Normandy Way, Hinckley
Technical Note – Response to LCC Highways
January 2026
Our Ref: 29480-TRAN-0802 – Revision A

LCC Highways Comments / MEC Response

Table 1: LCC comments (July 2025) / MEC response

Table 2: LCC comments (December 2025) / MEC response

APPENDIX E

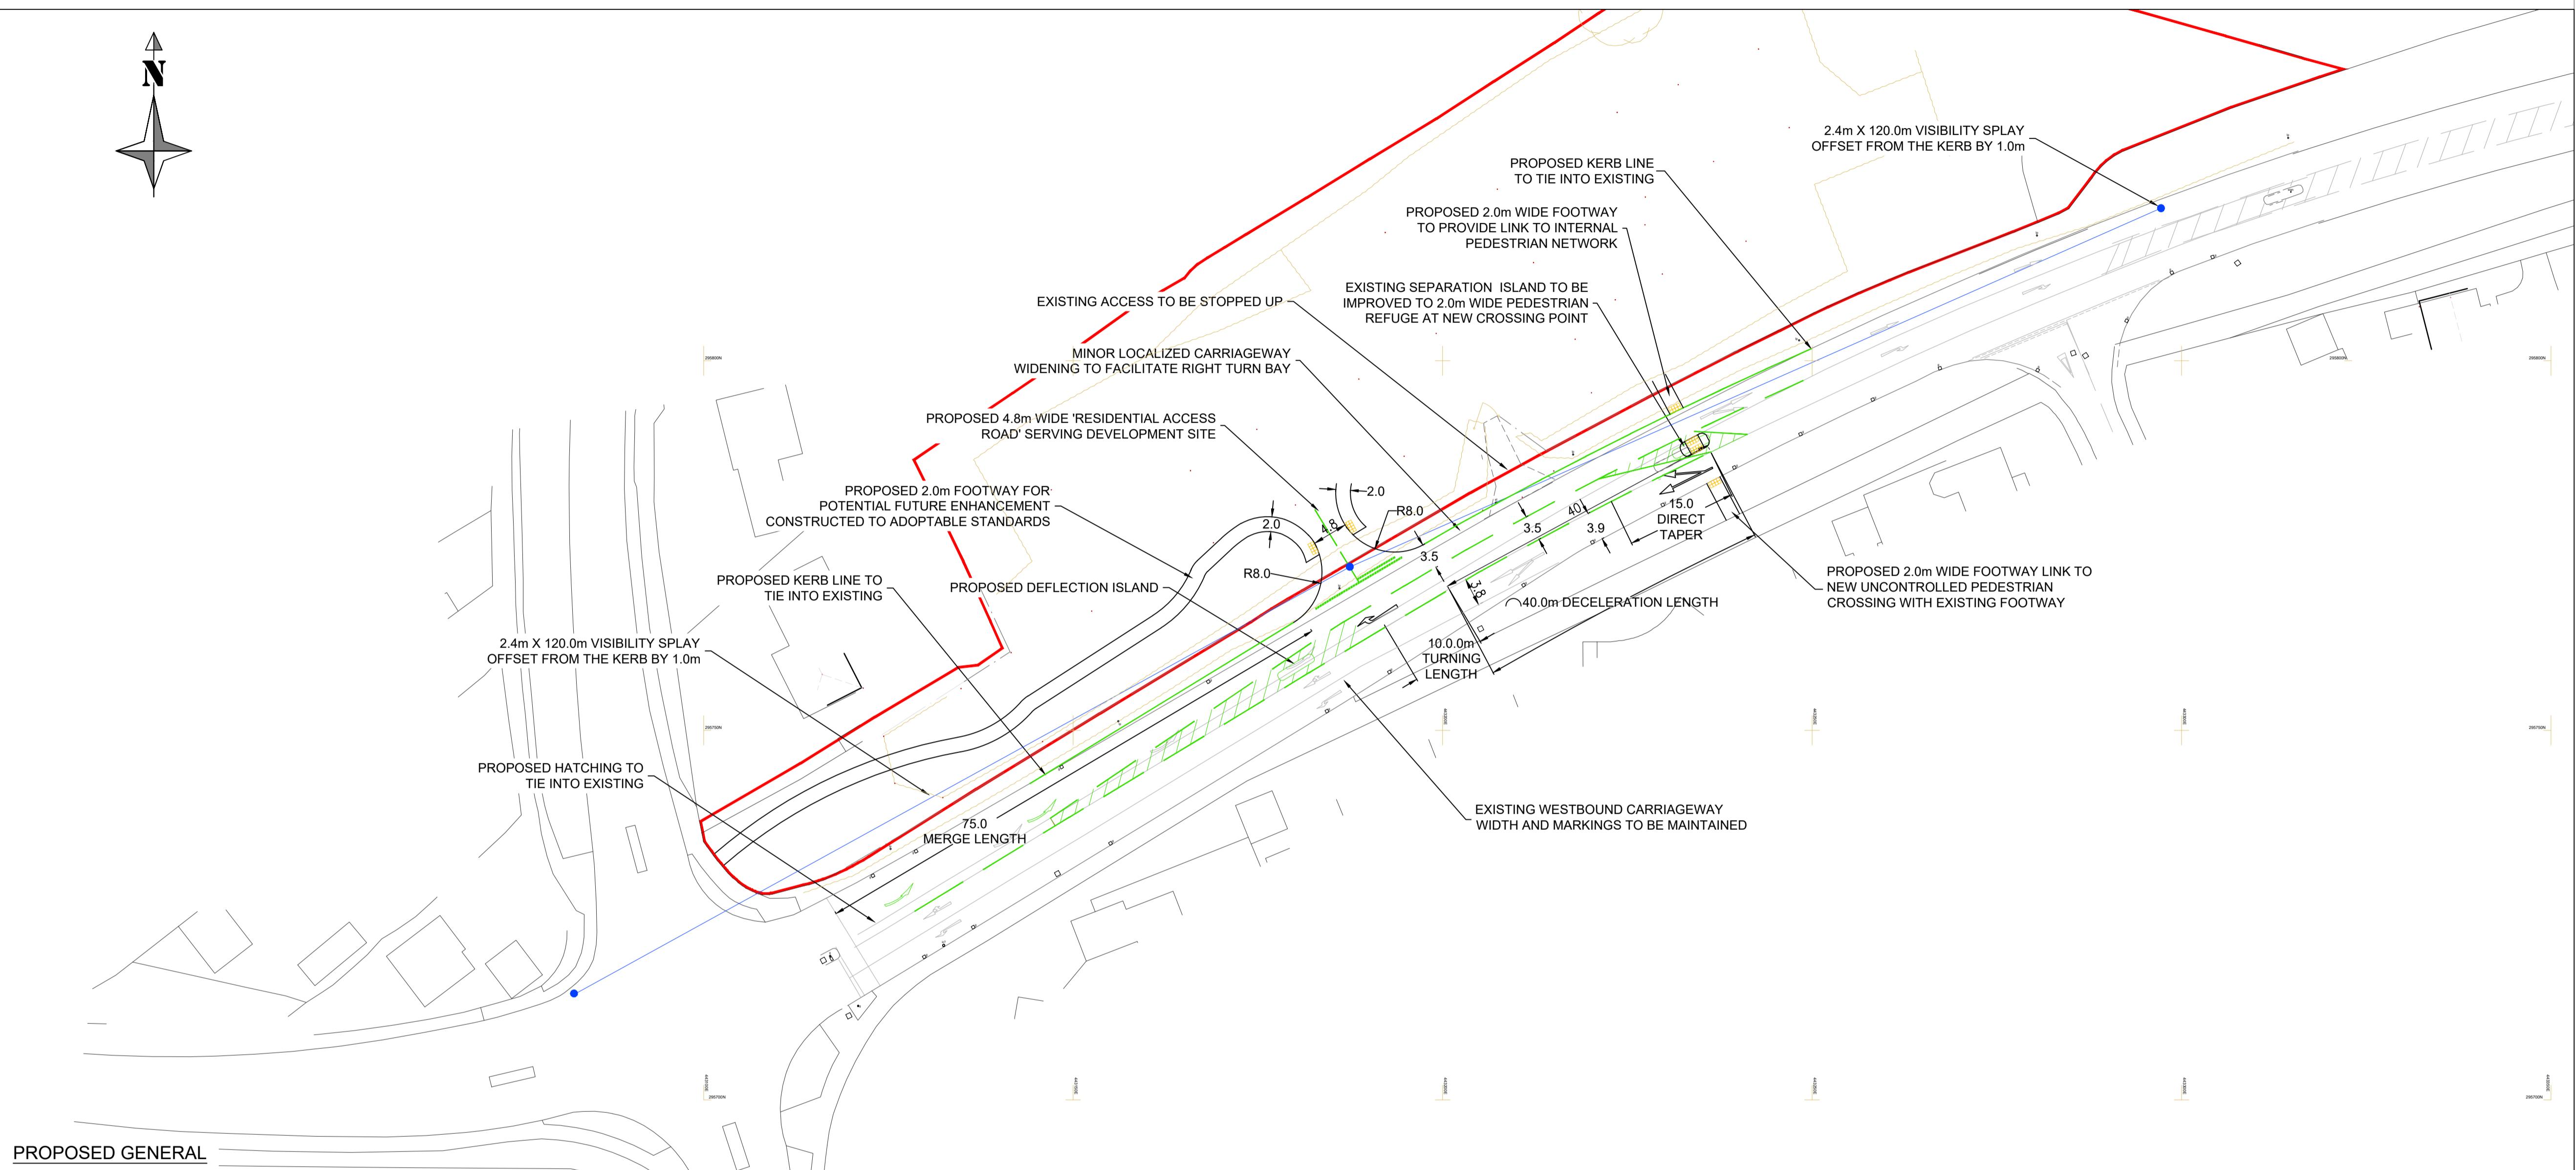
2	<p><i>“The drawing shows a merge length of 75m for eastbound traffic exiting the A47 Normandy Way/ A447 Ashby Road/ B4667 Ashby Road signalised junction.</i></p> <p><i>The LHA advise that it has concerns in respect of reducing the merge length as this could result in a reduction in the level of traffic using the merging lane. Given existing capacity concerns at the junction, the reduction in the length of the merging lane could have implications on the operation and capacity of the junction should less drivers choose to use it.</i></p> <p><i>The LHA is also aware of a junction improvement scheme required as part of application reference 22/00318/OUT (475 dwellings, land north of Normandy Way and east of Stoke Road, Hinckley). Condition 30 of the appeal decision (Appeal Ref: APP/K2420/W/23/3323113) states: ‘No part of the development hereby permitted shall be occupied until such time as either the offsite works shown on Dwg</i></p> <p>Firstly, the proposals in the March 2025 Transport Statement to reduce the length of the eastbound exit merge from 100m to 75m would not generate an “unacceptable impact in highway safety terms” given the advice of the DMRB for 100m lane continuity at signal junctions (Figure 7.12.1 of CD123) is guidance rather than mandatory. 75m would still enable 13 No. vehicles to merge at the end of the junction intervisibility zone, and would not generate an unacceptable highway safety impact in accordance with the NPPF. Moreover, the provision of a right turn bay will enhance road safety given existing site users currently block ahead movements whilst waiting to turn into the site.</p> <p>Secondly, the development proposals for right turn bay east of the A47 / Ashby Road Signalised Crossroads do not interfere with the committed improvements for application reference 22/00318/OUT given its proposals are exclusively contained on the northern, southern, and western sides of the junction.</p>

LCC comments:	MEC response:
	<p>No T19595-007 Rev C Ashby Rd/A47 Proposed Junction Improvements have been implemented in full, or an alternative scheme that mitigates the impacts of the development has been submitted to and approved in writing by the local planning authority and thereafter implemented in accordance with the approved scheme’.</p> <p>That application identified that the junction would be operating over its capacity in the AM peak in 2026 with committed development in place, and that the proposed development would exacerbate the situation. Furthermore by 2032, capacity at the junction was forecast to have deteriorated further and to the point that it would operate overcapacity in both the AM and PM peaks with that proposed development in place. The proposed scheme would present a nil detriment solution for the trips generated by that development.</p> <p>Currently an alternative scheme is being investigated by Leicestershire County Council to accommodate the wider growth in the area, however the LHA advises the proposed development access could prejudice the delivery of either scheme, given the proximity of the site access to the existing junction and the requirement to reduce the length of the merging lane.</p> <p>The LHA cannot see any reasonable way to resolve this concern as the site access could not be relocated further west towards the signalled junction and to relocate it further east would impact on the existing ghost right turn lane for the existing Cornwall Way estate.”</p>	<p>In capacity terms, MEC has checked the modelling conducted in 22/00318/OUT (Richborough Estates’ site approved at appeal) and can confirm the LinSig submitted has modelled the eastbound exit arm as ‘infinite saturation flow’. Therefore, the proposed reduction of 25m in the exit merge length in the March 2025 Transport Statement would have no capacity impacts given the modelling already accepted for Richborough at the junction. In addition, it is considered that an increase of 12 and 10 No. two-way vehicle movements in the AM 0800-0900 and PM 1700-1800 would be very unlikely to generate a severe impact on the operation of the road network.</p> <p>It is concluded that the development would be unlikely to generate a severe residual cumulative impact on the road network in accordance with paragraph 116 of the 2024 NPPF.</p> <p>In terms of LCC’s comments about “an alternative scheme is being investigated by Leicestershire County Council to accommodate wider growth in the area”, details of the scheme have never been shared by the highway authority to the Client. This is despite this being raised at pre-application stage and since. It is therefore considered that LCC highways has presented insufficient evidence in support</p> <p>The stance of the highway authority is therefore unreasonable in neither presenting the evidence in supports of its comments, which it is using as a basis for planning refusal, or providing sufficient detail to the LPA in support of its position.</p> <p>MEC has offered before, and can provide review of the proposed access arrangements into the site versus the LCC ‘alternative scheme’ when this is shared with the Client.</p> <p>It is concluded that the development would not prejudice the junction improvement scheme secured at planning appeal for the Richborough Estates development – and – insufficient evidence has been presented to the LPA by LCC highways in support of its position on LCC’s ‘alternative scheme’.</p>

Figure 1: Site Access.

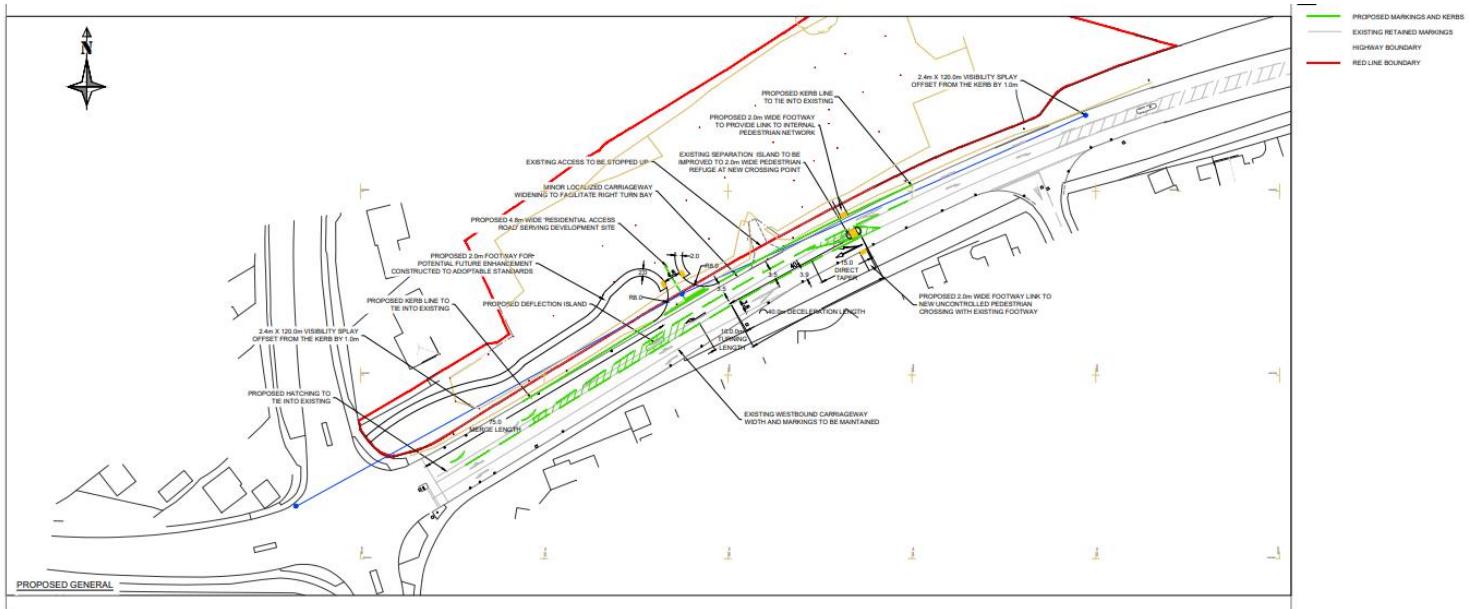
Access to the site is proposed off Normandy Way, a highly trafficked A classified road (A47) subject to a 40mph speed limit. The A47 Normandy Way forms part of the Department for Transport's Major Road Network¹ and Leicestershire County Council's Resilient Network². The Applicant proposes to permanently close the existing access to the site, which serves allotments, and replace it with a new 4.8m wide access slightly further to the west and a ghost right turn lane. It does not appear the existing access has been in regular use to serve the allotments for a considerable amount of time and on a site visit on 3rd June 2025, it was observed the access was blocked with concrete barriers. The Application form details that there are no car parking spaces within the existing allotment site.

- The merger would achieve a length of 75m which is considered suitable to CD123 Figure 7.12.1 given lane continuity to east of the junction intervisibility zone is not significantly less than a “recommended” 100m by the standard; and
- This will allow approximately 13 No. car lengths (75m / 5.75m) to be accommodated in free flow conditions of around 40mph 85th percentile speeds which is considered a suitable distance for vehicles to merge before the lane becomes single carriageway.

Based on the recorded vehicle speeds referenced above and [Figure 6](#) of the LHDG, visibility splays of 2.4 x 120m would be required to the west of the site access and 2.4 x 73m to the east. The Applicant has shown visibility splays of 2.4 x 120m in each direction, which is considered acceptable to the LHA. Visibility would be achievable subject to the removal of the existing hedgerow along the site frontage between the site access and the A47 Normandy Way/ A447 Ashby Road/ B4667 Ashby Road signalised junction. This is proposed on BRP Architects drawing number M170-BRP-00-00-DR-A-0102 Rev. P02.
